D060145-A

PLEASE NOTE D050444 IS SHOWN.  
FOLLOW INSTRUCTIONS ON REPLACEMENT  
SHEET FOR D050444.

UNLESS OTHERWISE SPECIFIED DIMENSIONS ARE IN INCHES		DATE	NAME	PARTS LIST	
DRAWN	2-16-96	KEM	LIGO CALIFORNIA INSTITUTE OF TECHNOLOGY MASSACHUSETTS INSTITUTE OF TECHNOLOGY		
CHECKED			SYSTEM	LHD /LLO	
			SUB-SYSTEM	TCS	
			NEXT ASSY	NONE	
			PART NAME	QUAD SUS FIXTURE ASSEMBLY	
			SIZE	DWG. NO.	REV
			D	D060145-A	
			SCALE:	SHEET 1 OF 2

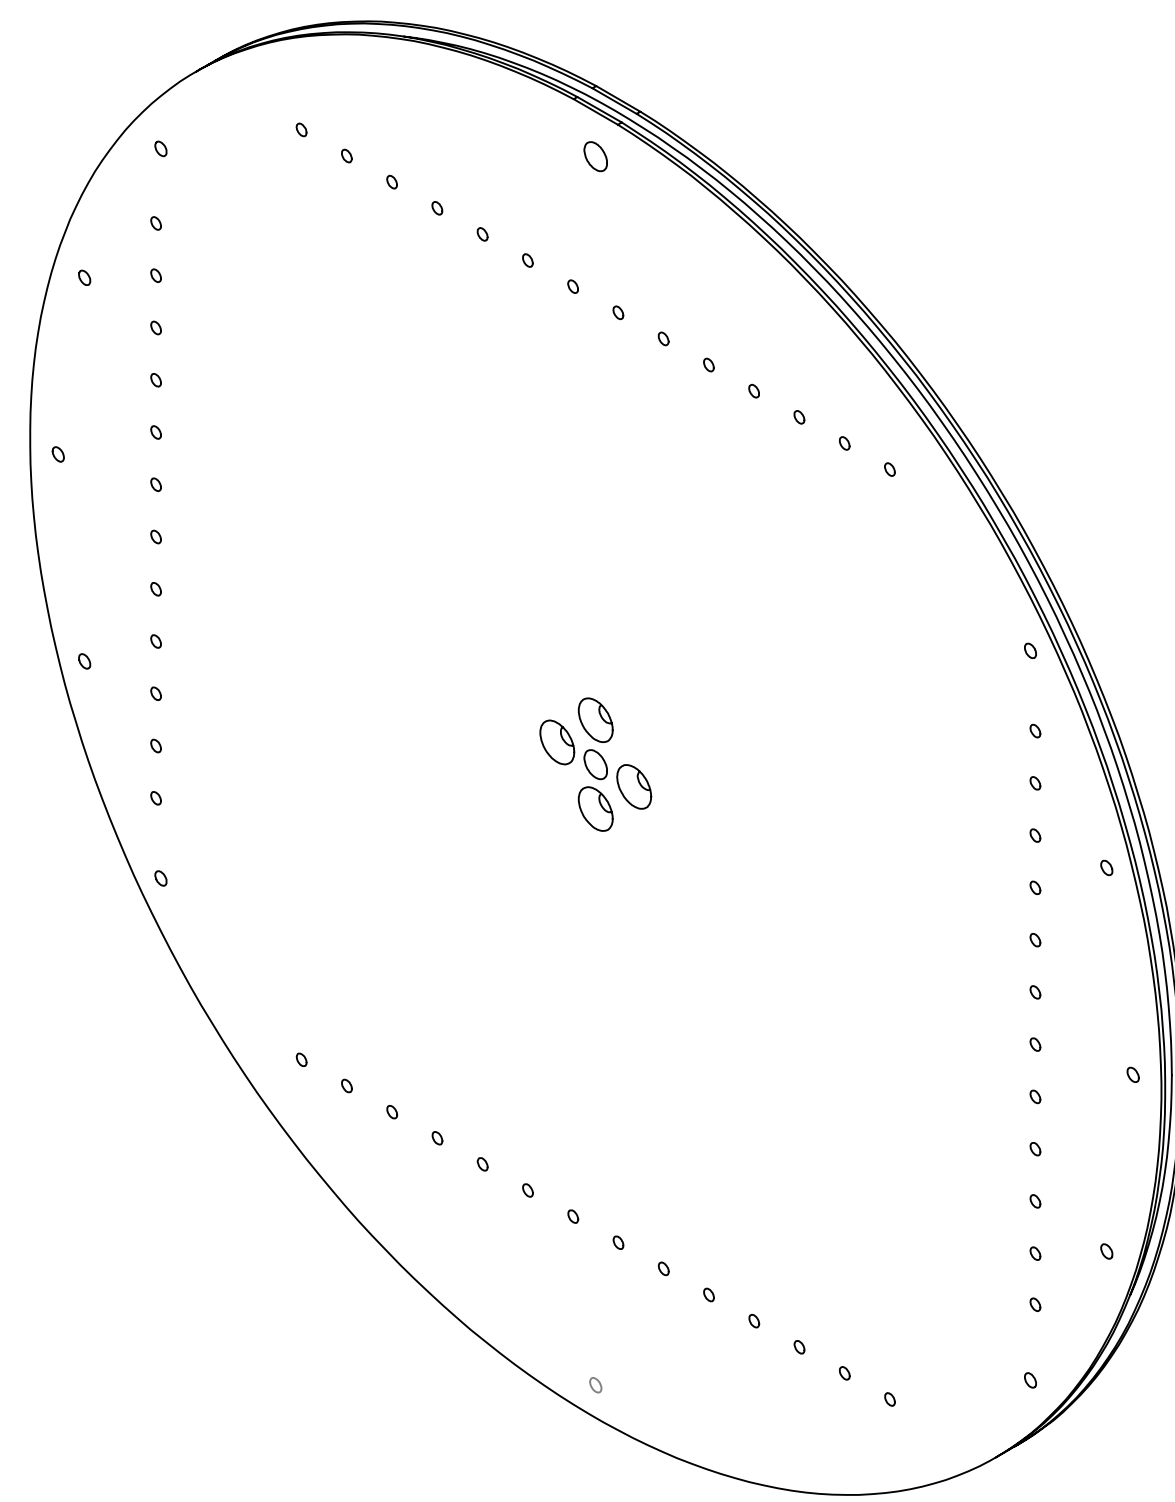
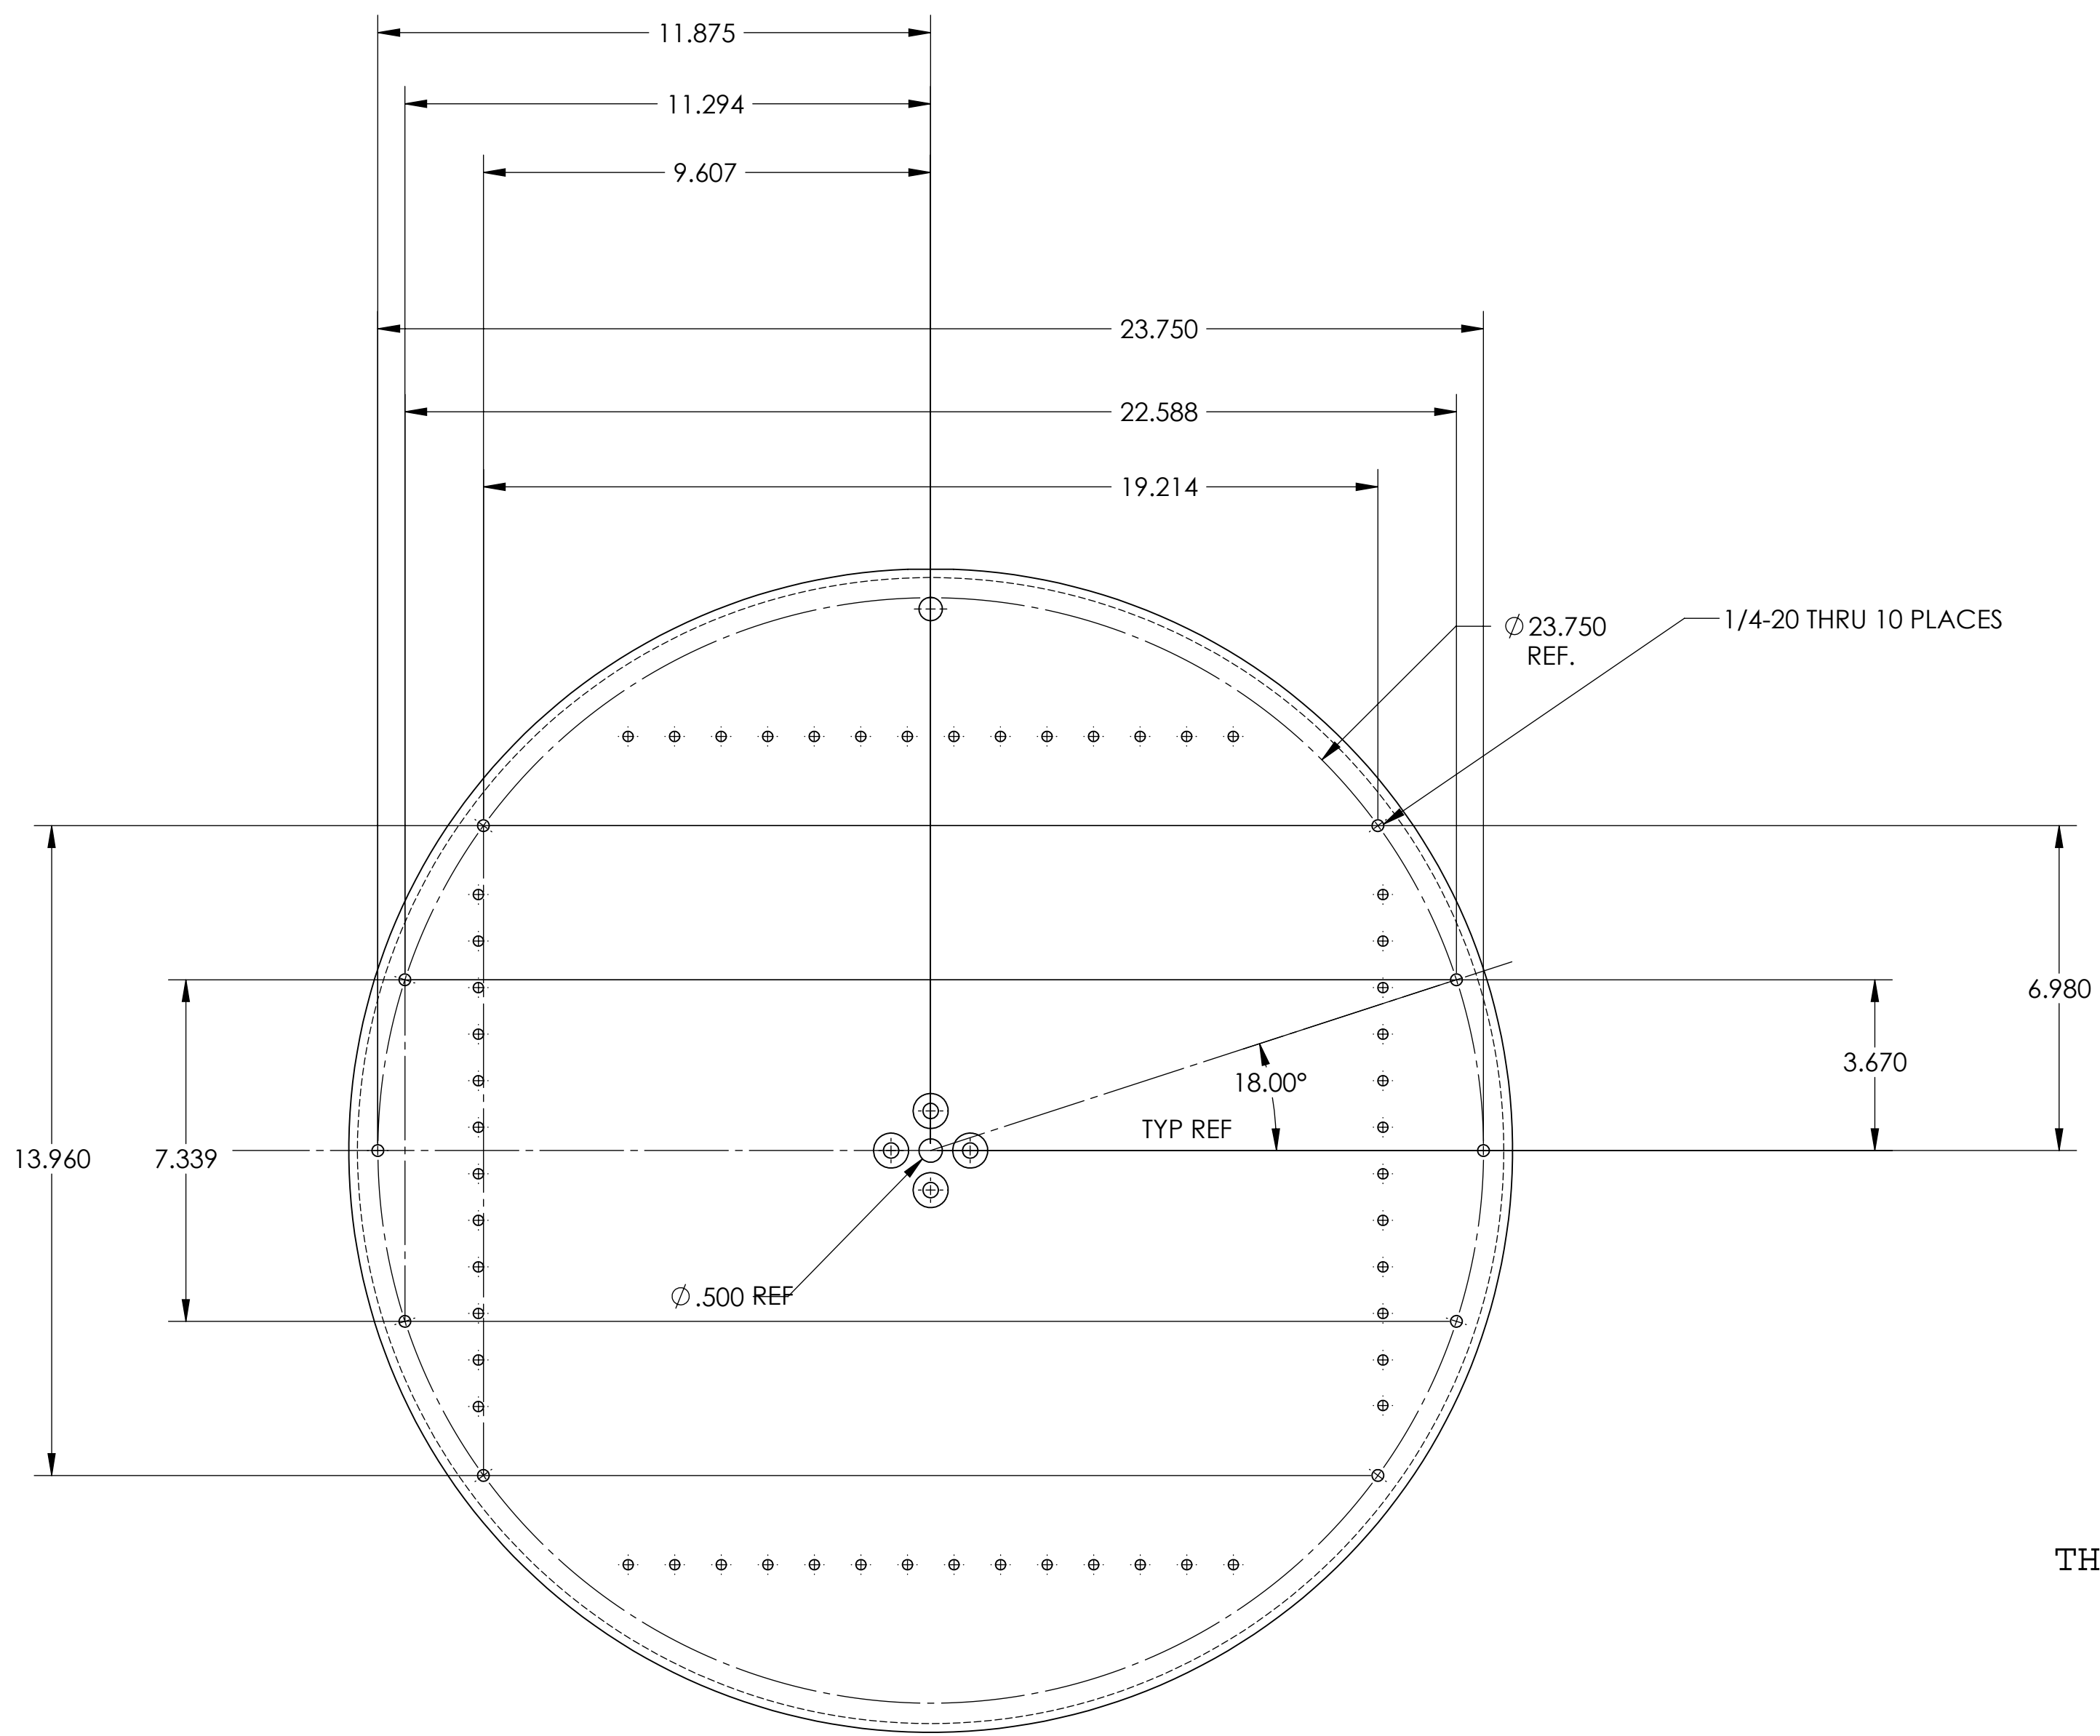
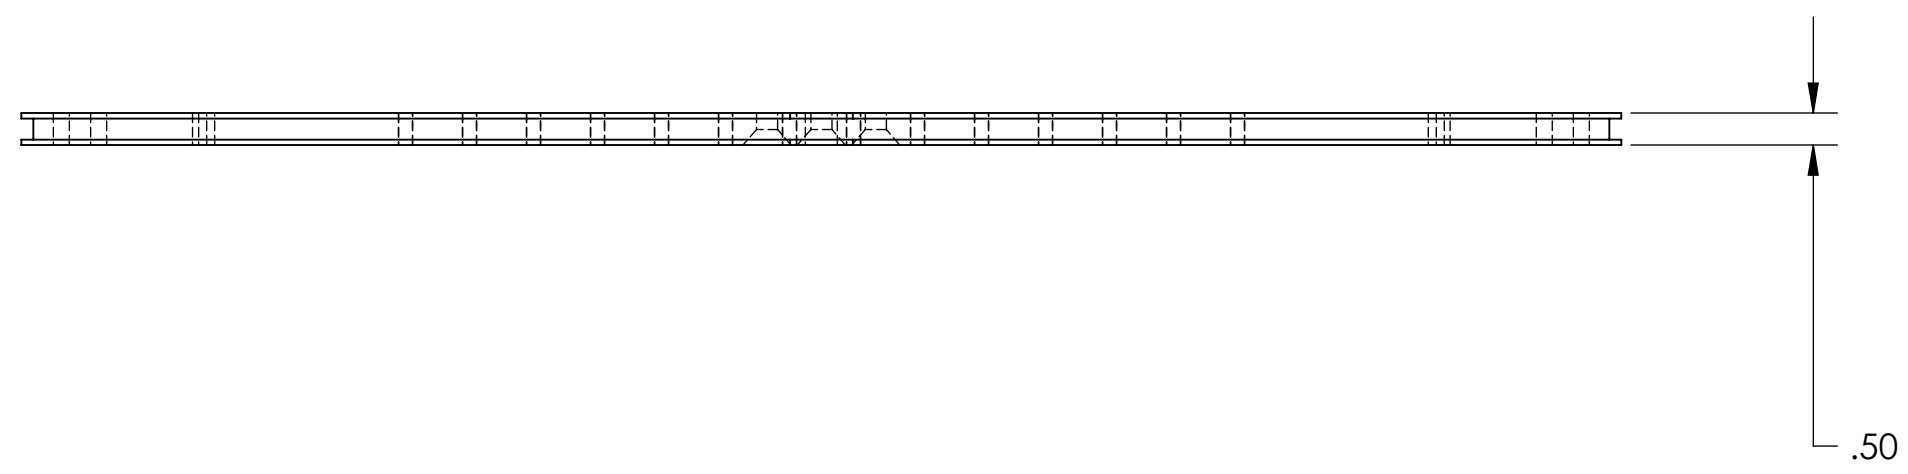
ADD 1/4-20 TAP HOLES TO EXISTING PLATE AS SHOWN

THIS IS A MODIFICATION TO D050450-A AND SHOULD BE INLCUDED AS PART OF THE QUOTE.

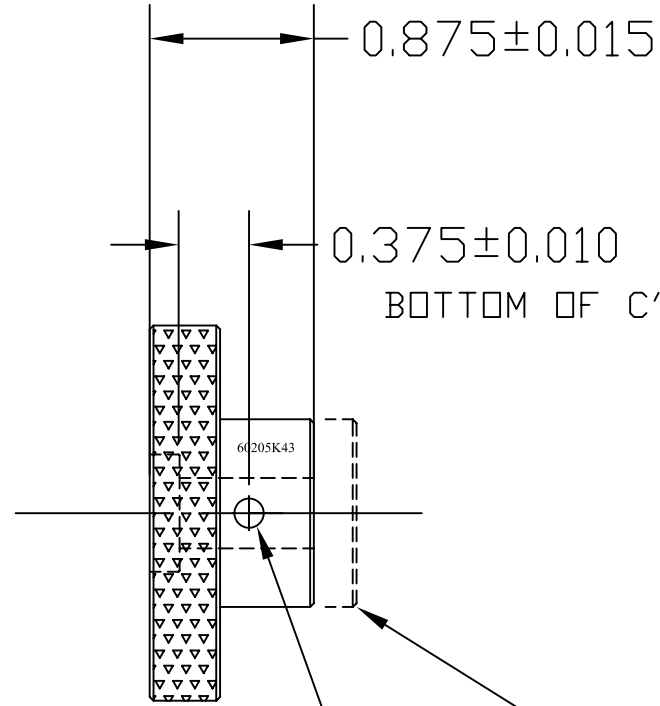
DRILL AND REAM LPF FOR  
~~.156 DIA ROLL PIN THRU~~  
BOTH WALLS INLINE

drill thru #20 [.161 dia]  
not LPF for .156

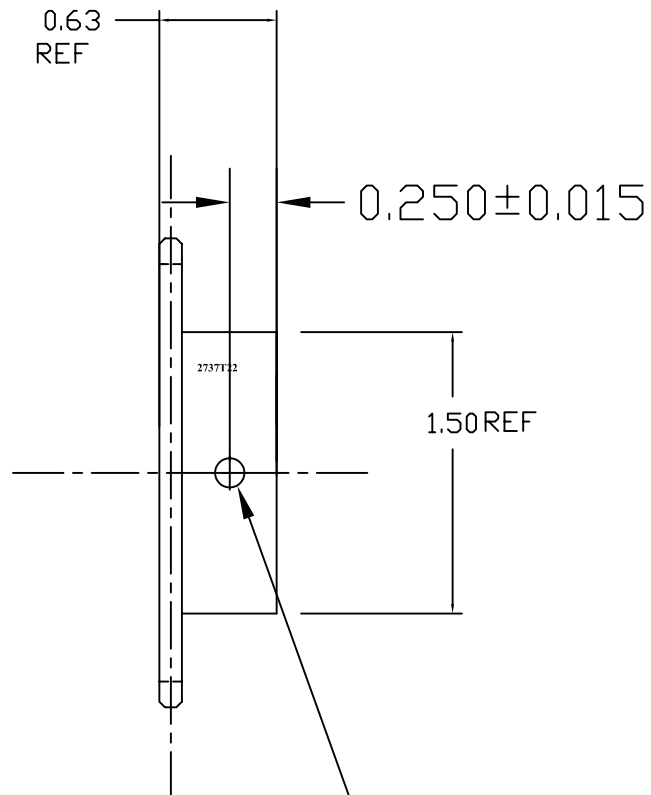
DRILL AND REAM LPF FOR  
~~.156 DIA ROLL THRU BOTH~~  
WALLS

drill #20 [.161 dia]  
not LPF .156

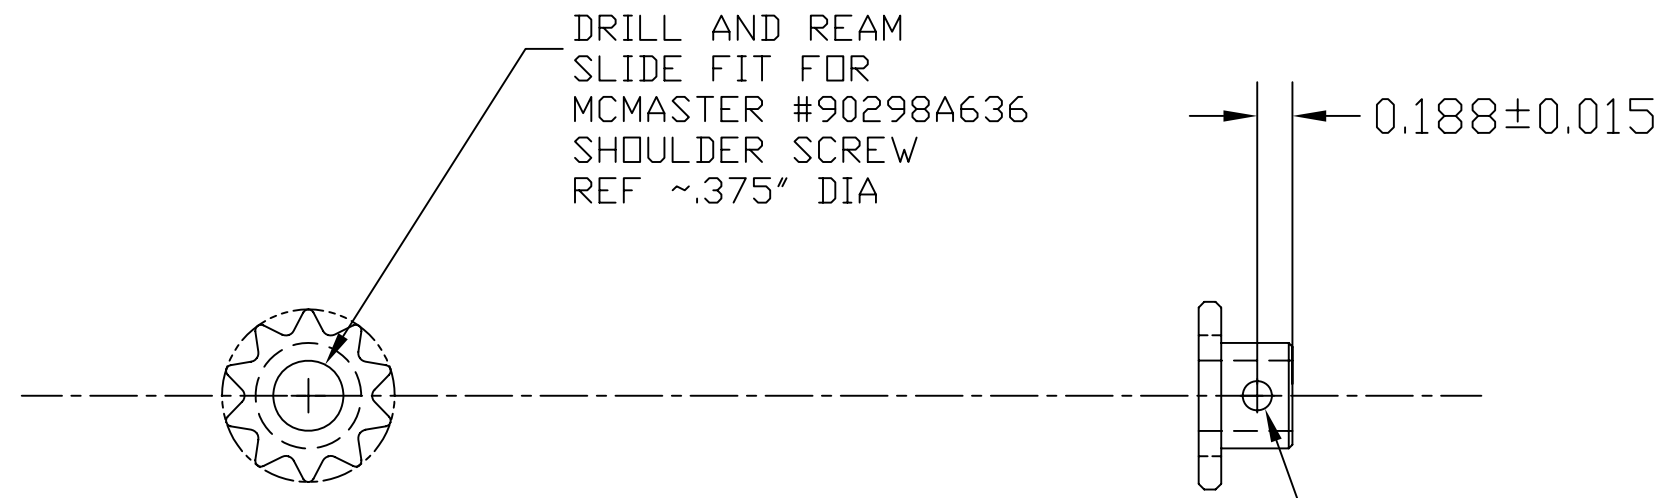
MATCH DRILL AND REAM  
~~LPF FOR .156~~ DIA ROLL PIN  
THRU ALL [center in  
existing set screw hole]  
see assembly for  
adjacent part

drill thru #20 [.161 dia]  
not LPF .15 CIT

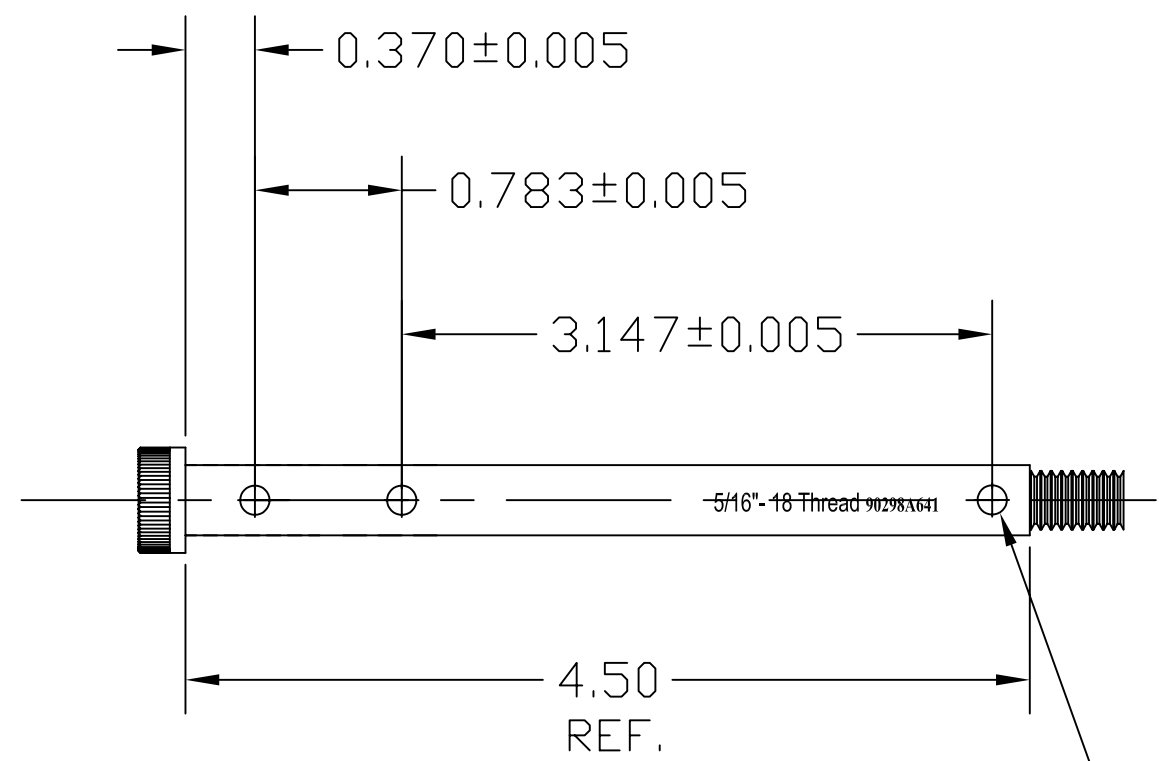
DRILL AND REAM LPF FOR .156 DIA  
ROLL PIN THRU 3 PL.

drill #20 [.161 dia thru]  
not LPF .156
